Re: Proposed 3A Stockpile, Modification 14-2 to Permit No. GR009RE

Freeport-McMoRan Chino Mines Company (Chino) is in receipt of your letter dated November 14, 2014 providing the Mining and Mineral Department (MMD) and other state agencies' comments on the proposed 3A Stockpile. Chino submits the following information below in response to each of MMD's comments and comments from other state agencies. The responses below clarify and supplement information submitted with Chino's application dated July 10, 2014 to modify Permit No. GR009RE.

FREEPORT-McMORAN COPPER & GOLD	
Conceptual 3A Reclamation Drainage Plan	
Scale: As Noted	Date: 12-16-2014
Dept. Reclamation	
Drawn By: DHA	Checked By: LL

Figure 7

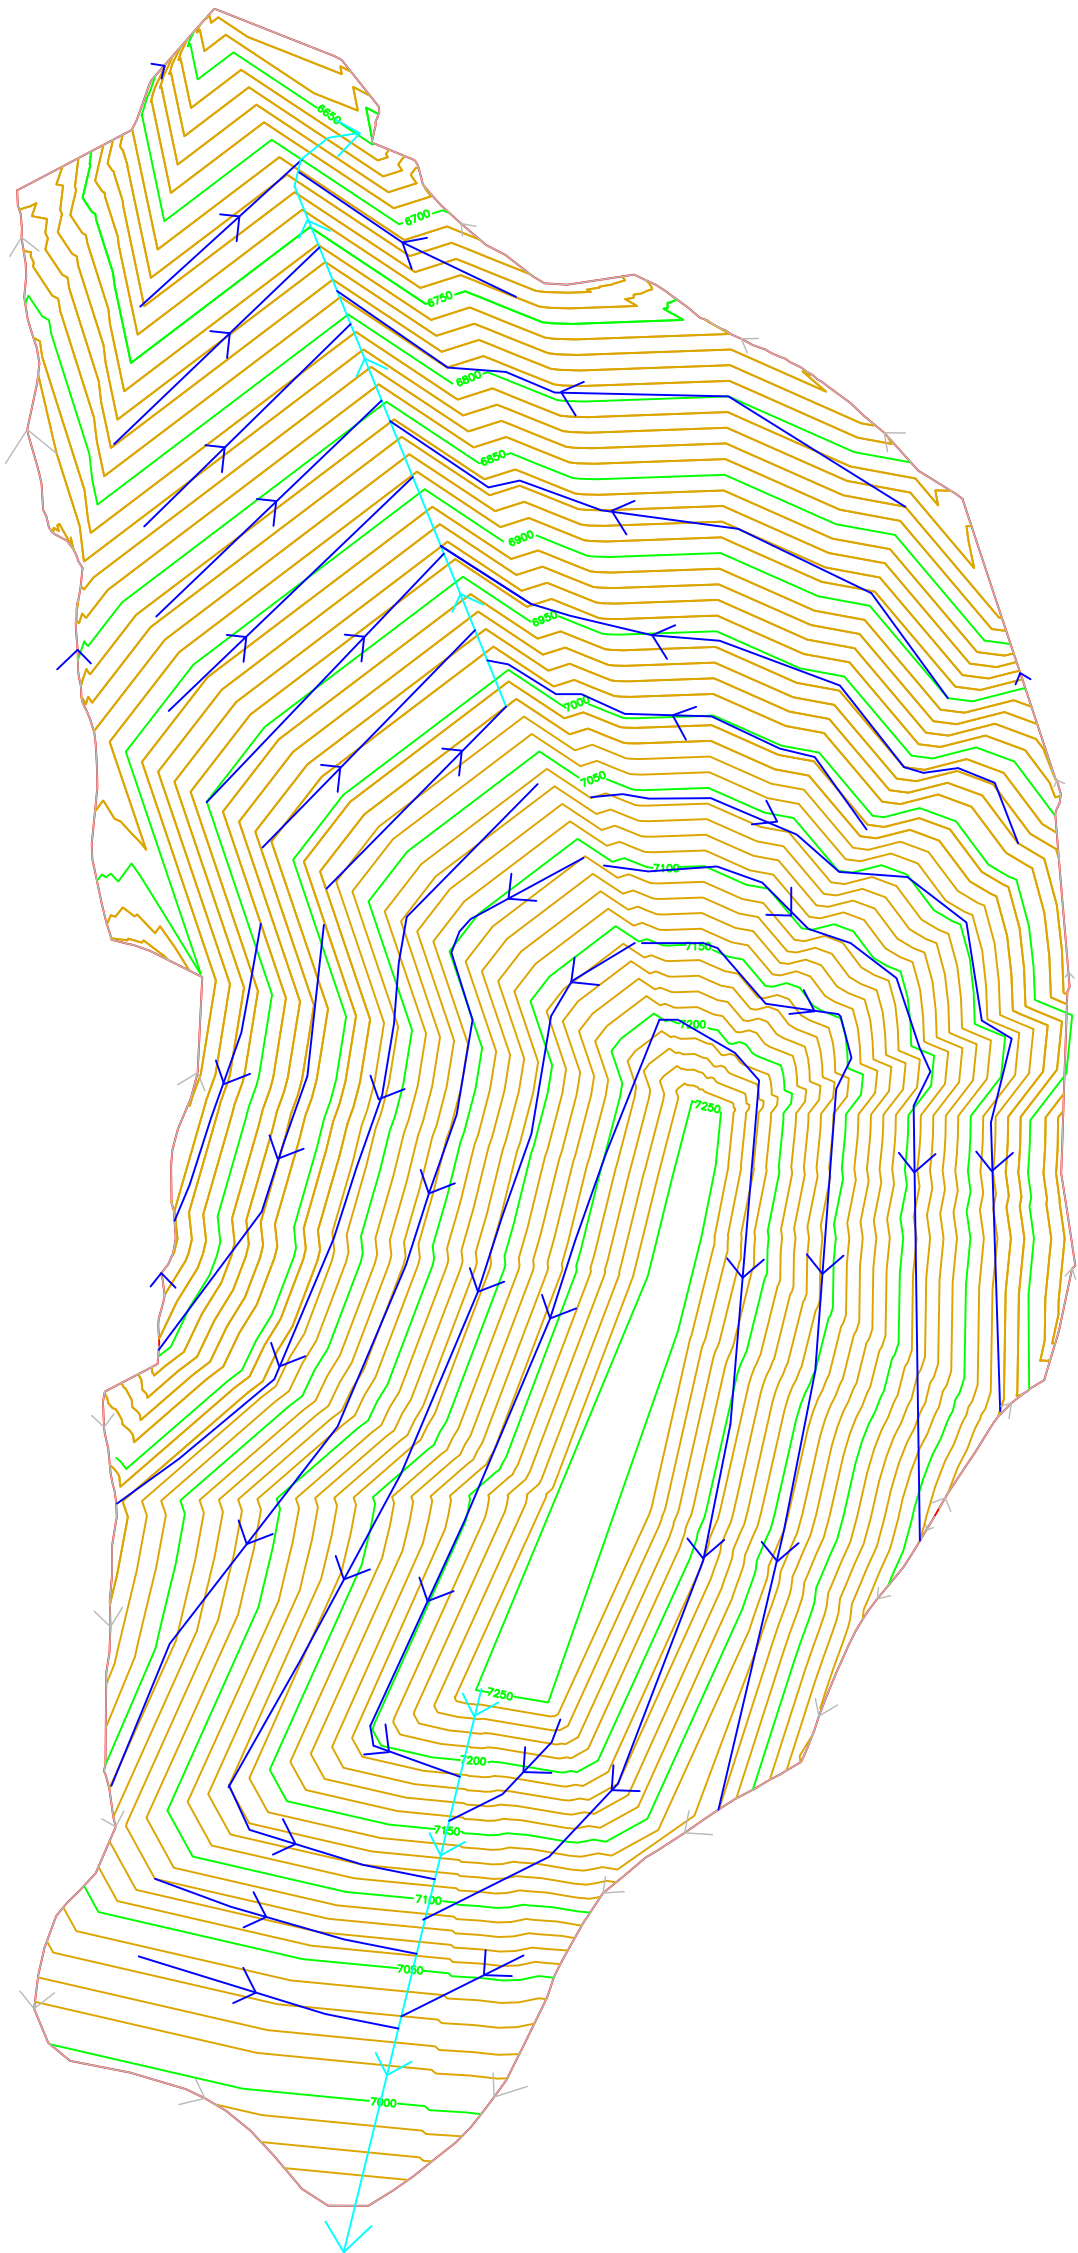
5. The application should include a general description of appropriately designed stormwater drainage and diversion features, water treatment, and associated armoring, to manage a 100 year, 24-hour storm event. Please revise the application to include this description and a cost estimate to address these storm water design features.

The designs and plan proposed under this modification are consistent with the requirements of Permit GR009RE and DP-1340 as well as the newly adopted Copper Mine Rule (NMAC 20.6.7). Surface water control on the reclaimed slopes will be achieved using armored terrace bench channels and downdrains sized to handle a 100 year 24-hour storm event. Construction of the Stockpile and ultimate reclamation will result in a lower site-wide water treatment volume compared to the current CCP because at closure stormwater can ultimately be released south of the Stockpile. In the current approved CCP, all water reports to the Santa Rita open pit. Figures 5, 6 and 7 in the referenced application illustrate the typical conceptual designs for the slope configuration, channels, and downdrains including rip rap. The application shows the full build out of the Stockpile with the associated FA. Detailed designs would be submitted prior to actual reclamation activities based upon the final Stockpile design configuration. The designs submitted with the application support the reclamation cost estimate in the application. Table 8 of the application includes a cost estimate for these design features.

An updated Figure 7, dated December 16, 2014, is included with this response indicating the down stream direction of channel flows for the reclaimed Stockpile.
